**Union County High School  
Field House**

**Addendum No. 1**

**December 5, 2019**

Architect's Commission Number: 19097.00

**1.02 SHEET C120; UTILITY PLAN SOUTH:**

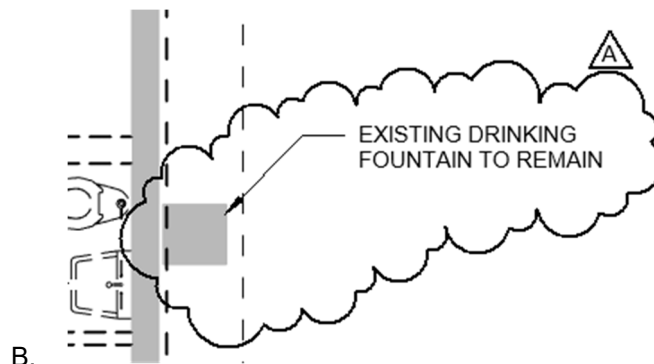
- A. This sheet is re-issued and revised as shown by clouded outline indicated as Revision A, dated December 5, 2019, and is attached to this Addendum.
- B. Revised the proposed gas line route from the LP tank to the building in order to avoid storm line conflict as shown.

**A101**

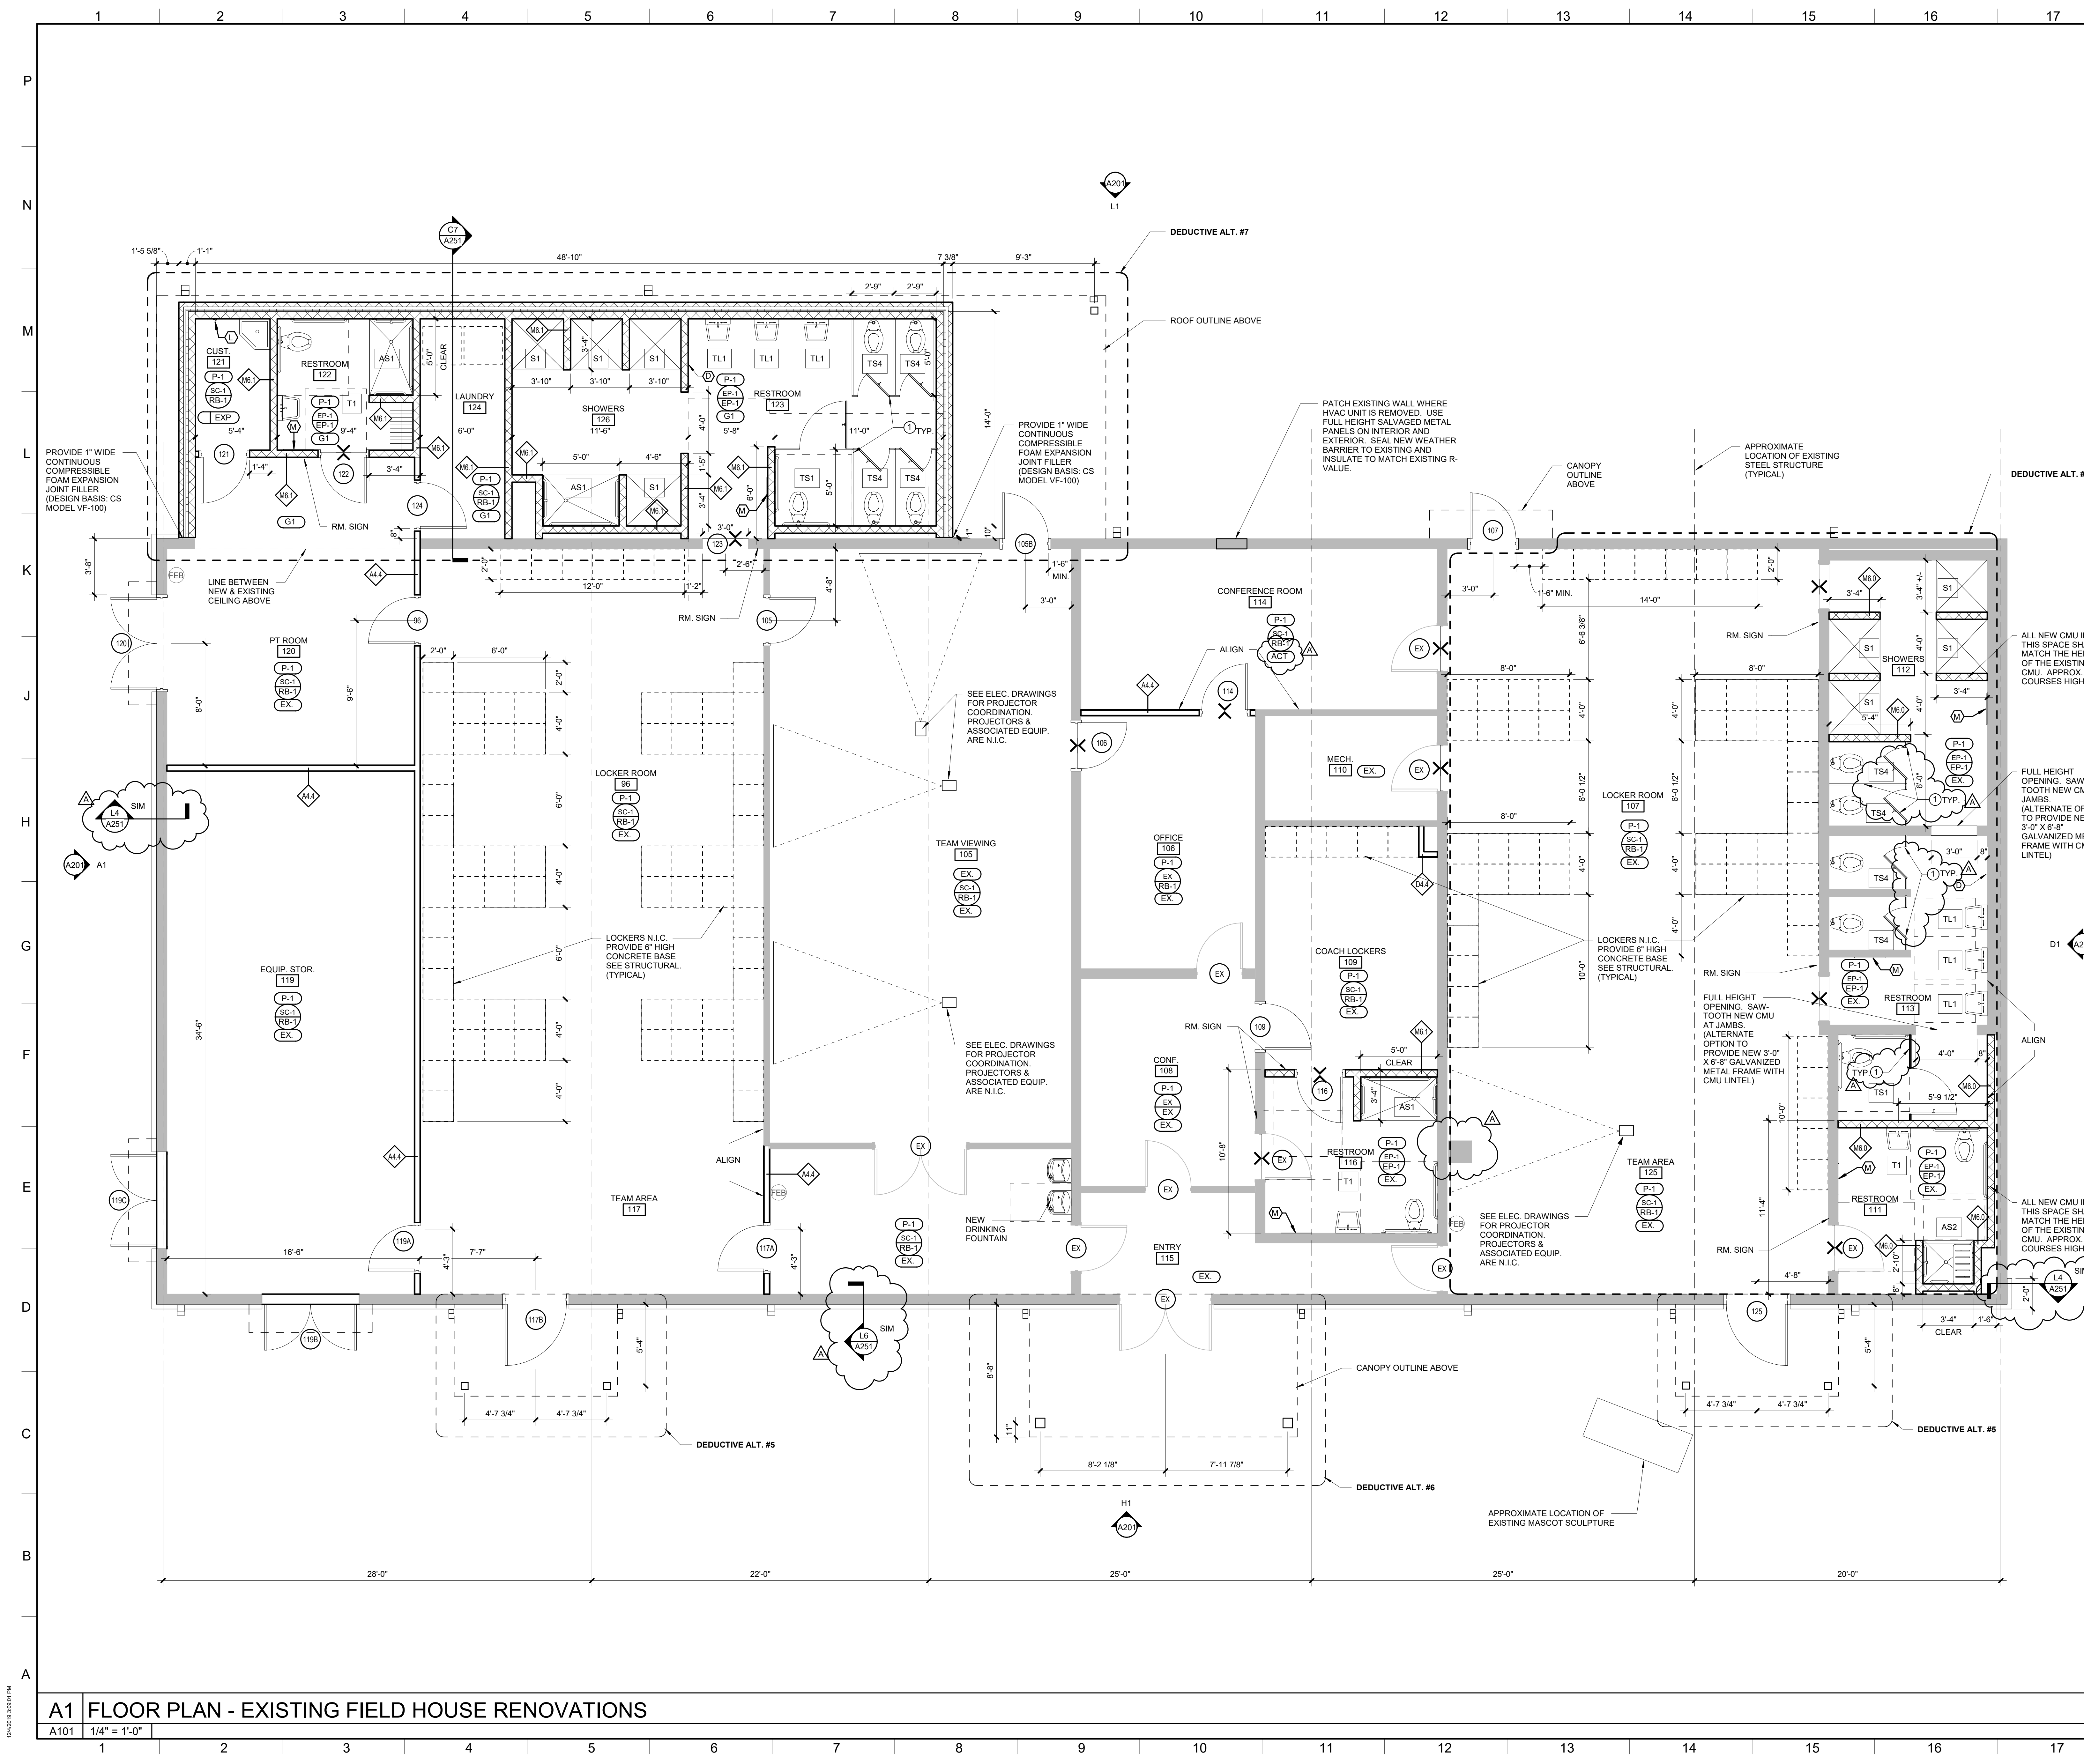
- A. This sheet is re-issued and revised as shown by clouded outline indicated as Revision A, dated December 5, 2019, and is attached to this Addendum.
- B. Note #1 provided for new solid phenolic toilet partitions including design basis.
- C. Note tags provided for the new solid phenolic toilet partitions on the plans.
- D. Section tags for detail L4/A251 and L6/A251 have been provided to clarify location and extent of CMU water table conditions.
- E. 2X4 Acoustical Ceiling Tile added to CEILING TYPE NOTES.
- F. ACT ceiling tag added to CONFERENCE ROOM 114.
- G. Existing drinking fountain shown in TEAM AREA 125.
